**SUBJECT:** NuScale Power, LLC Supplemental Response to NRC Request for Additional Information No. 282 (eRAI No. 9196) on the NuScale Design Certification Application

## **Response to Request for Additional Information Docket No. 52-048**

**eRAI No.:** 9196

**NRC Question No.:** 19-36

**Figure 9.3.4-1: Chemical and Volume Control System Diagram**

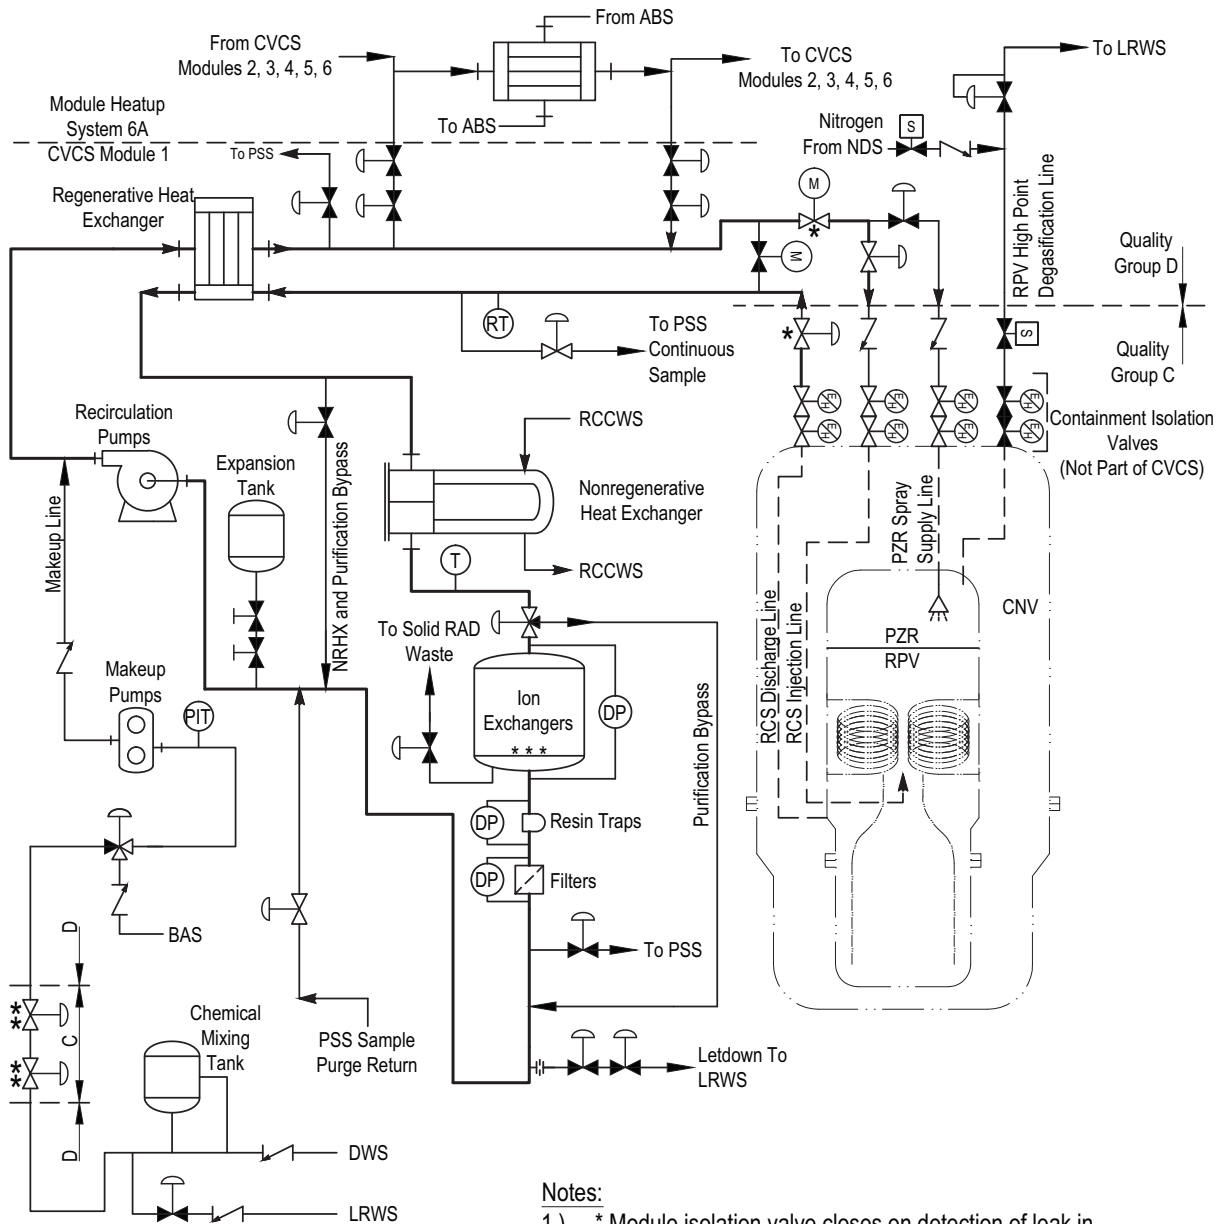
The information in FSAR Section 9.3.4 indicates that CVCS subsystems may not meet the guidance in SECY-93-087. FSAR Table 9.3.4-1 lists 150 psig as the design pressure for the CVCS Chemical Mixing Tank and the CVCS Expansion Tank.

The information in FSAR Section 9.3.4 indicates that CVCS connecting systems (i.e., systems that are connected to the RCS via the CVCS) may not meet the guidance in SECY-93-087. CVCS connecting systems (e.g., liquid radioactive waste system, demineralized water system, process sampling system, boron addition system) are shown in Figure 9.3.4-1. FSAR Table 9.3.4-2 lists 125 psig and atmospheric pressure as the design pressure for two of the components in the boron addition system which is a CVCS connecting system.

FSAR Figure 9.3.4-1 has been revised to include the pressure indicating transmitters on the suction of each of the CVCS makeup pumps. The figure has also been revised to show the check valve that is provided between the makeup pumps' discharge and the injection tee into the recirculation loop.

FSAR Section 9.3.4.3 and Figure 9.3.4-1 have been revised as described in the response

RAI 09.03.02-3, RAI 09.03.02-4, RAI 09.03.02-5, RAI 09.03.02-6, RAI 09.03.02-8, RAI 9.3.4-4, RAI 19-36S1
